**SECTION 00 90 01
BIDDING AND CONTRACT REQUIREMENTS
ADDENDUM NUMBER 1**

Issued: April 28, 2026

**Fire Tower Replacement
Issued for Bid**

Architect's Project Number: 25-028

SHEET NUMBER:
E1.10

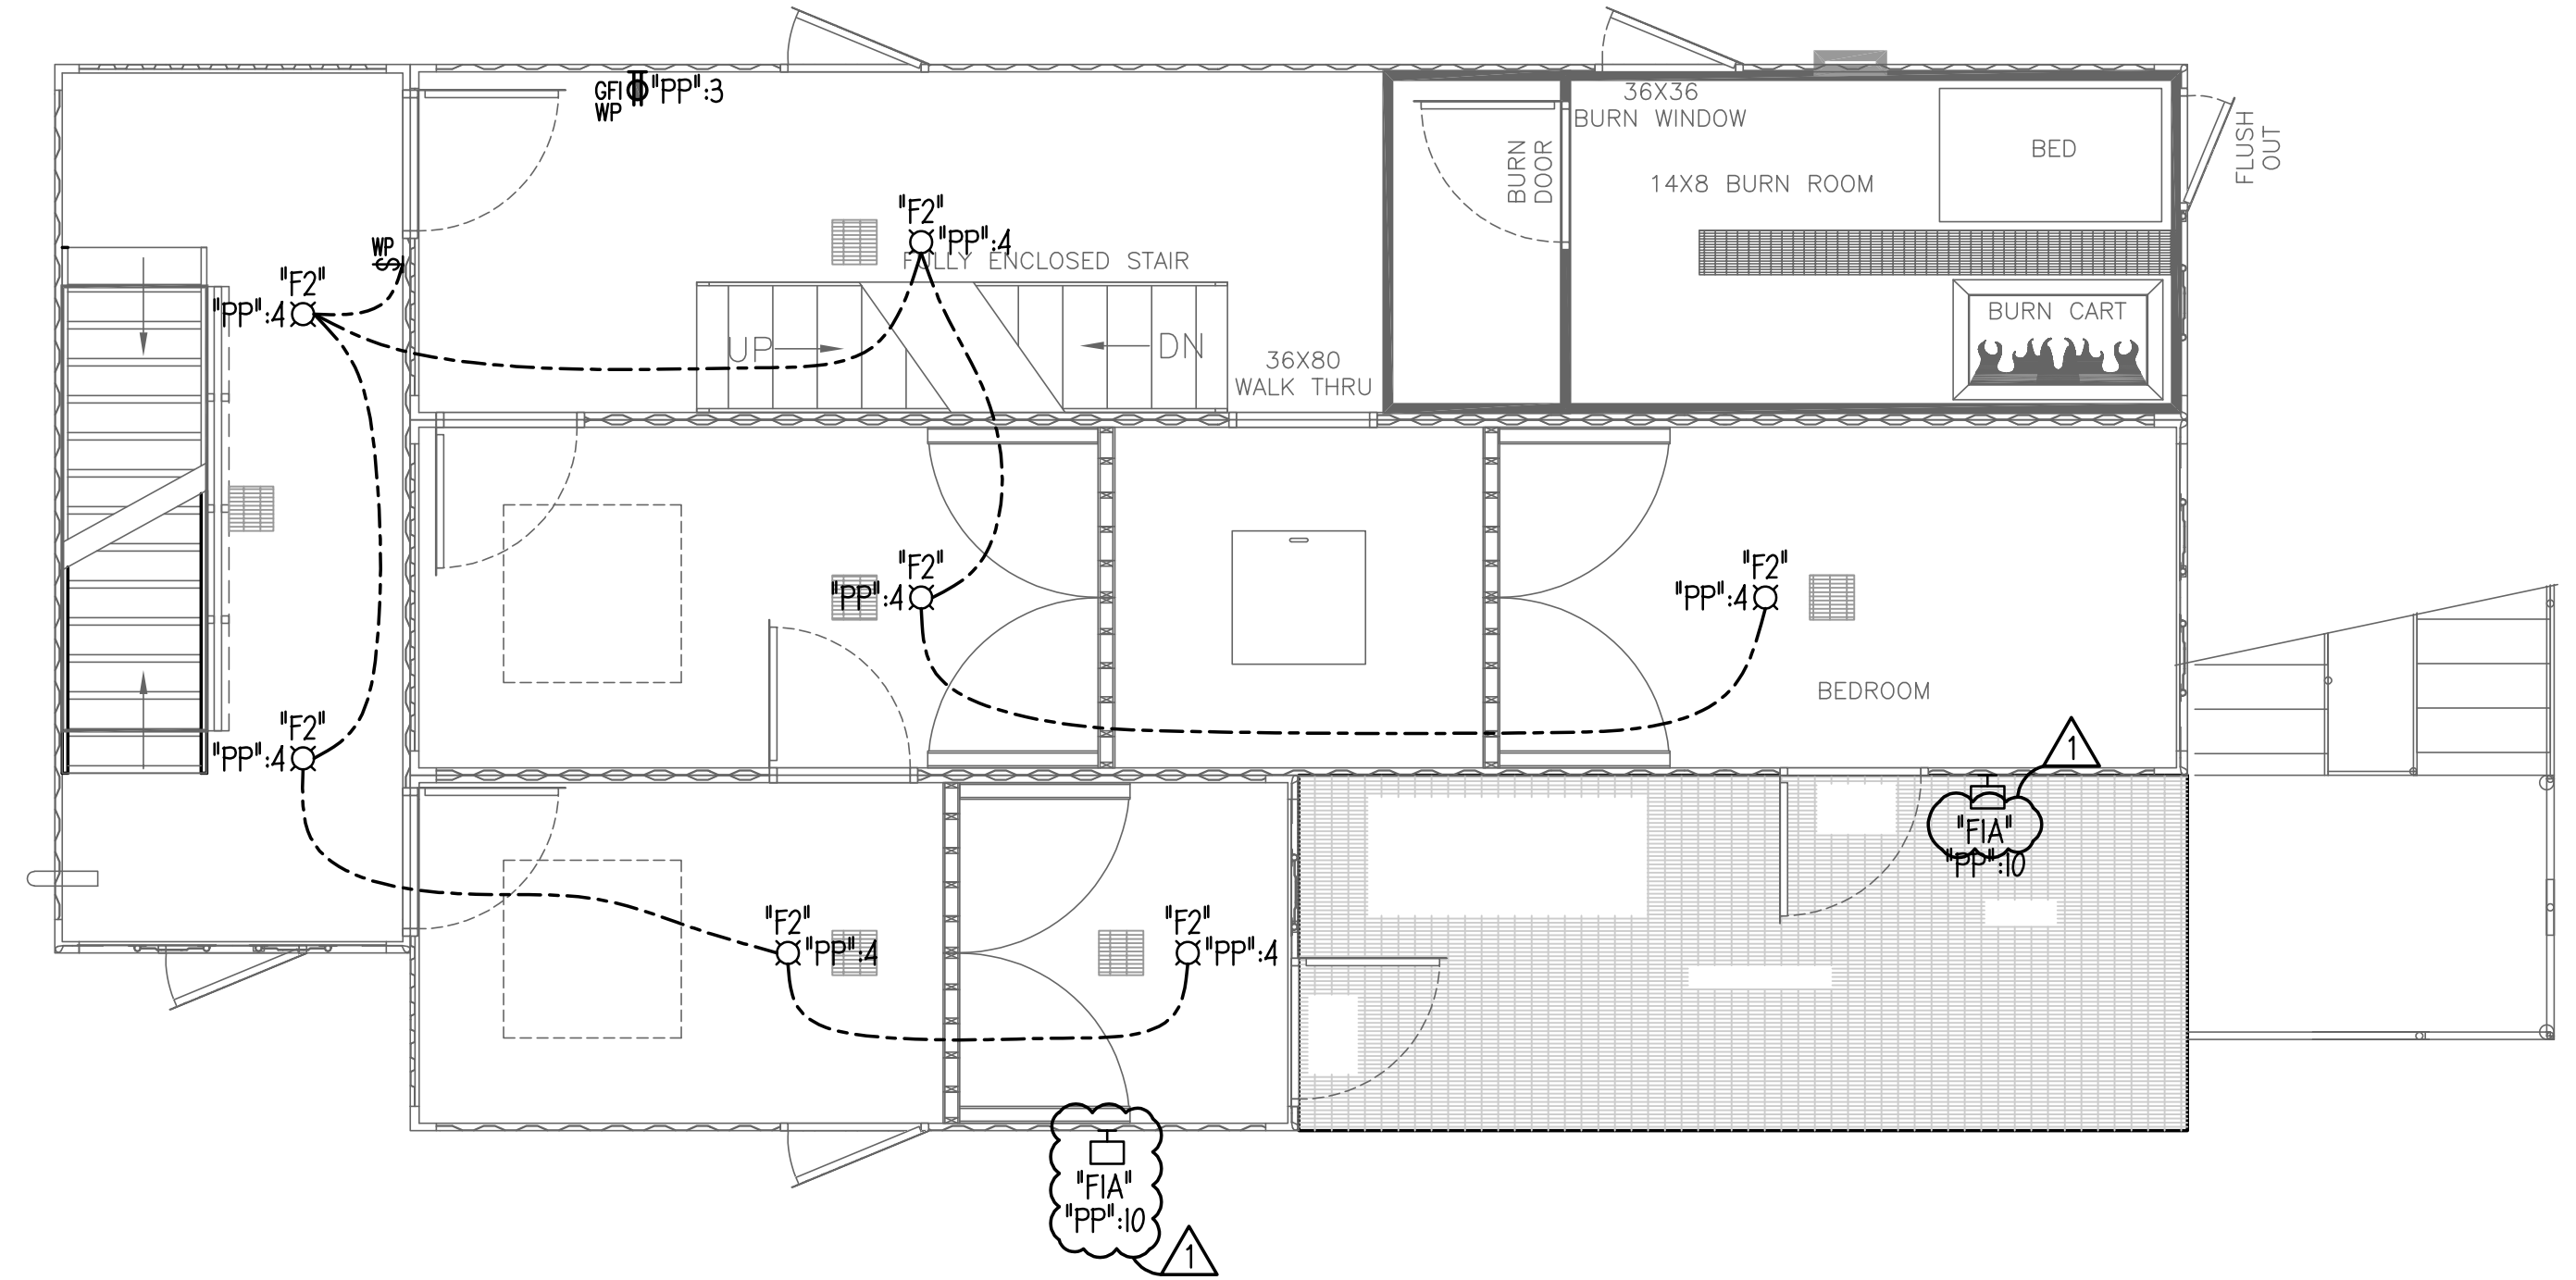
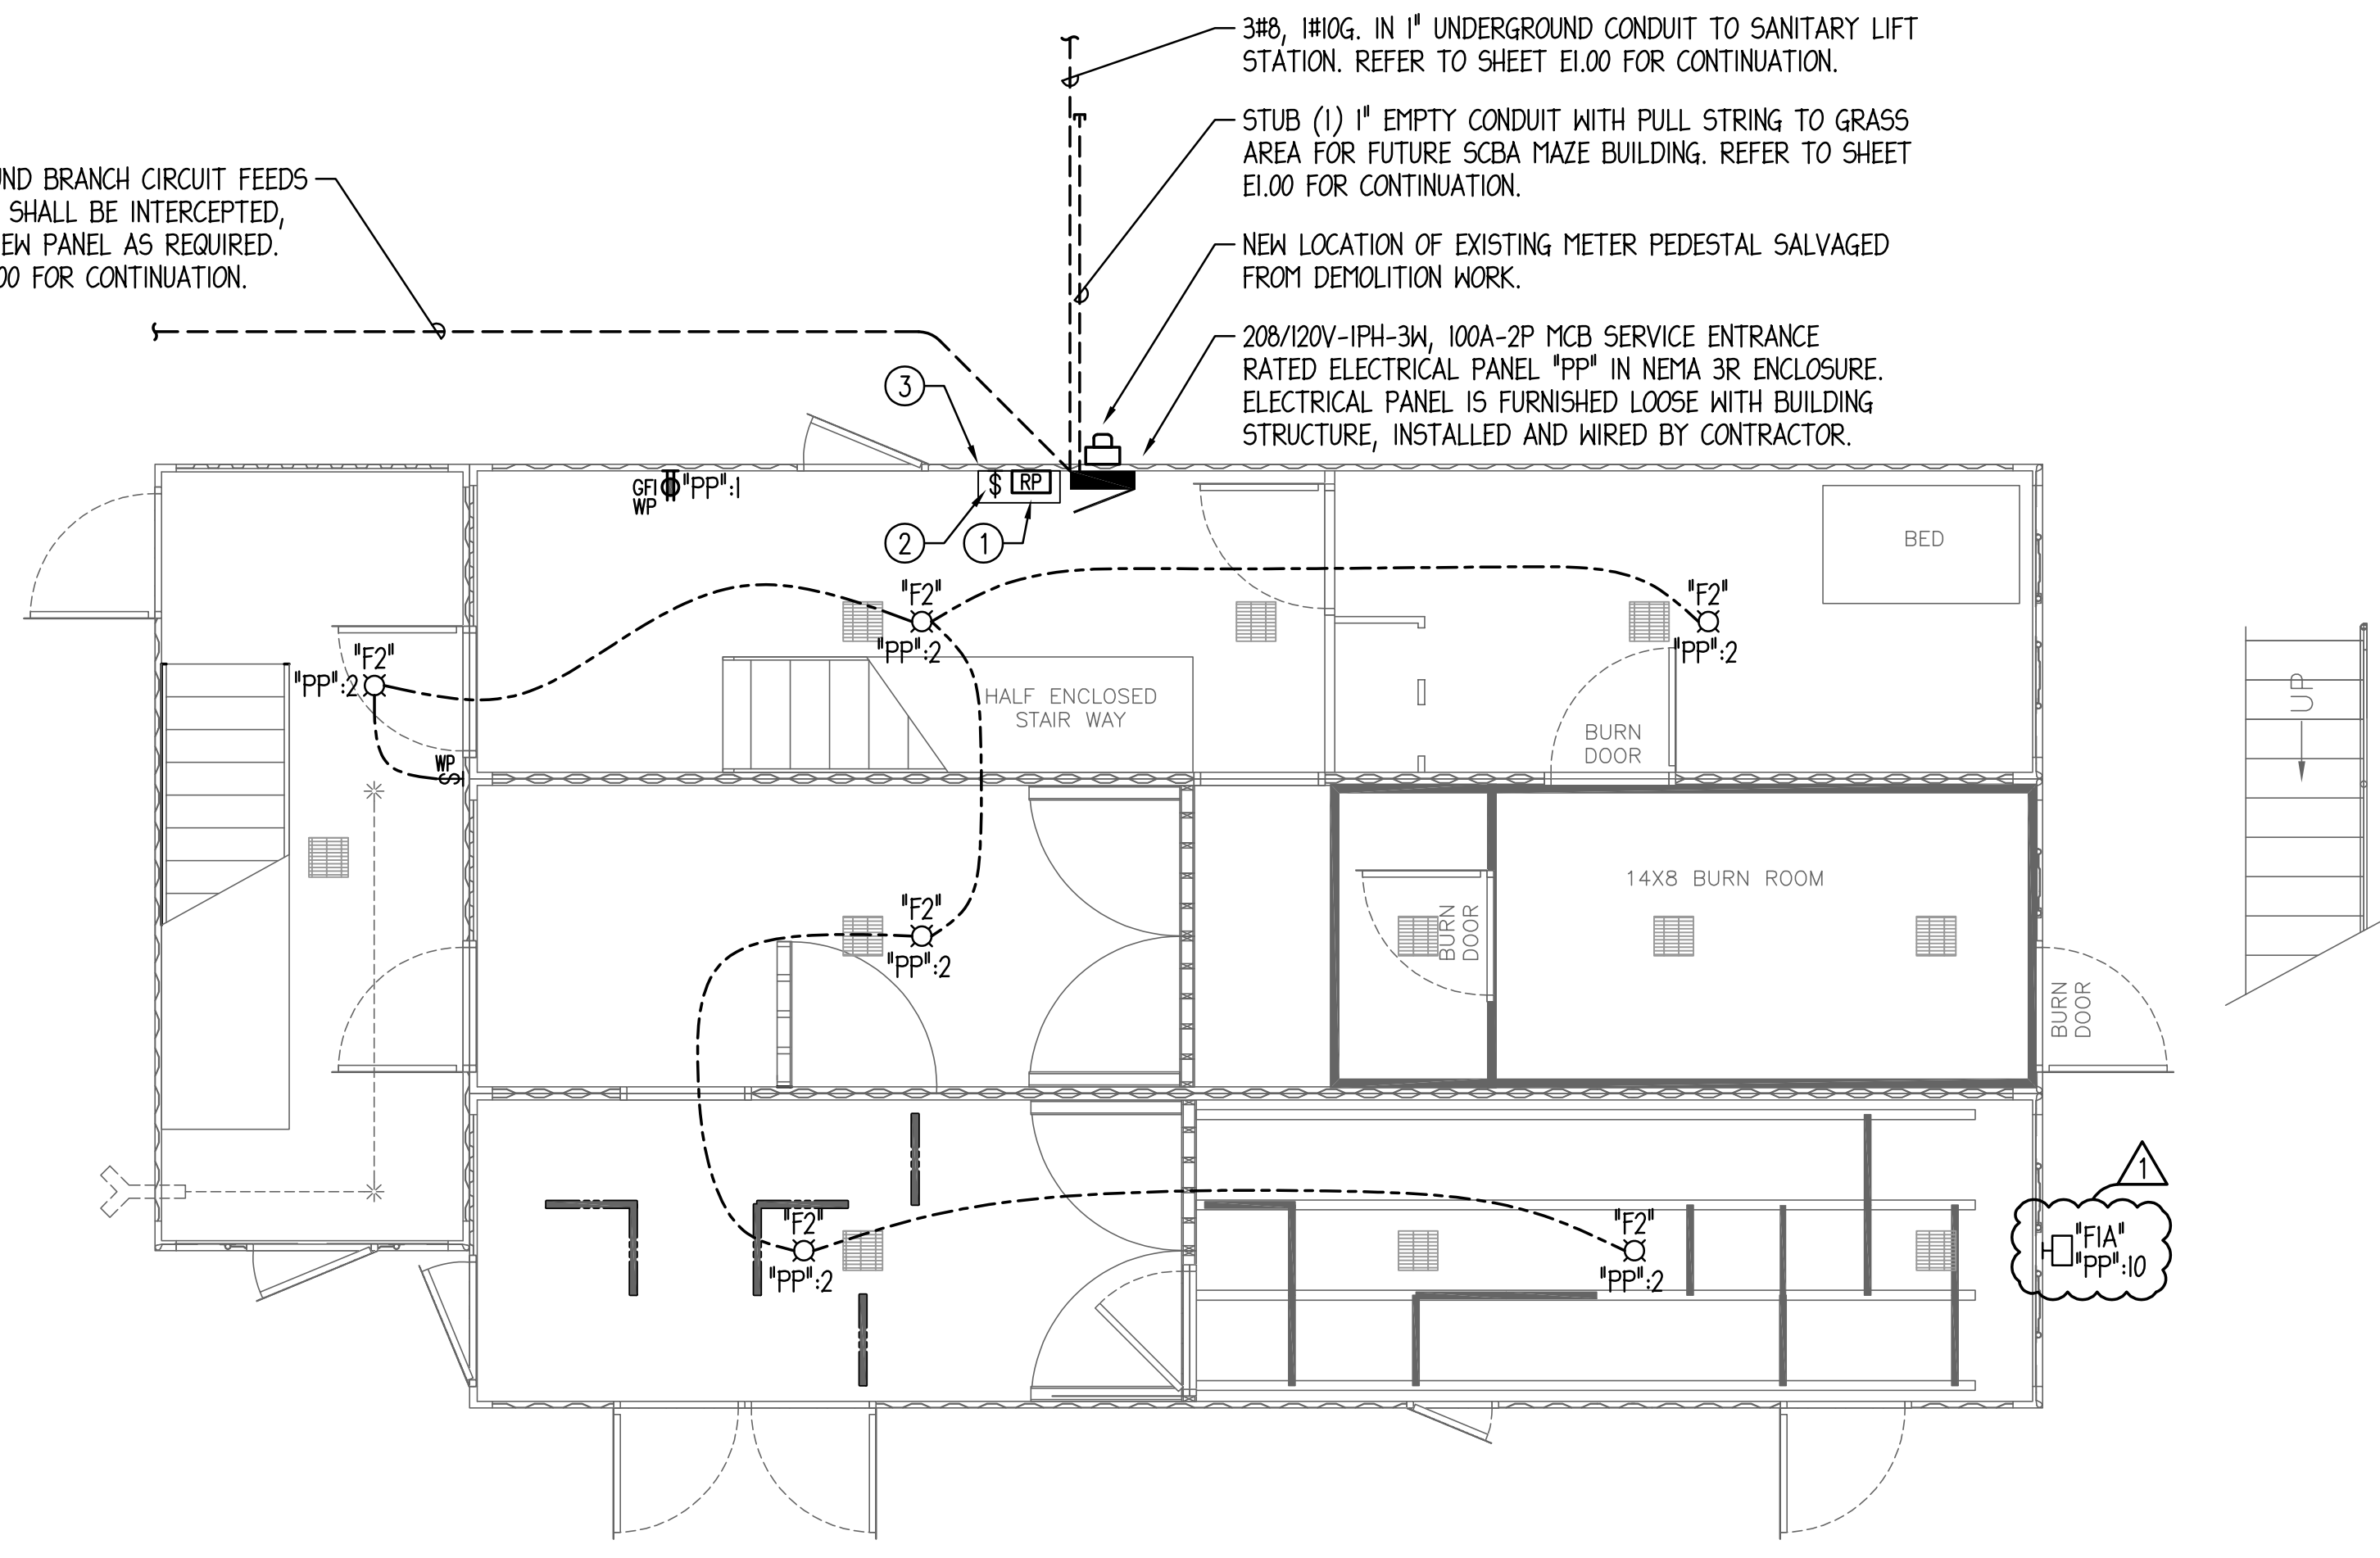
1. E1.00
 - A. **ADD** note for installation of conduits below concrete drive.
 - B. **REVISE** note for conduit stub out to future SCBA maze building.
2. E1.10
 - A. **ADD** general note #6 to drawing.
 - B. **ADD** luminaire shown on 'FIRST FLOOR ELECTRICAL PLAN'.
 - C. **ADD** luminaire shown on 'SECOND FLOOR ELECTRICAL PLAN'.
3. E1.20
 - A. **ADD** general note #6 to drawing.
 - B. **REVISE** luminaires shown on 'THIRD FLOOR ELECTRICAL PLAN'.
 - C. **REVISE** luminaires shown on 'FOURTH FLOOR ELECTRICAL PLAN'.
4. E2.00
 - A. **REVISE** 'LUMINAIRE SCHEDULE' as shown.
 - B. **REVISE** 'LIGHTING CONTROL RELAY PANEL SCHEMATIC DIAGRAM'.

STUB (1) 1" EMPTY CONDUIT WITH PULL STRING TO GRASS AREA FOR FUTURE SCBA MAZE BUILDING. REFER TO SHEET E1.00 FOR CONTINUATION.
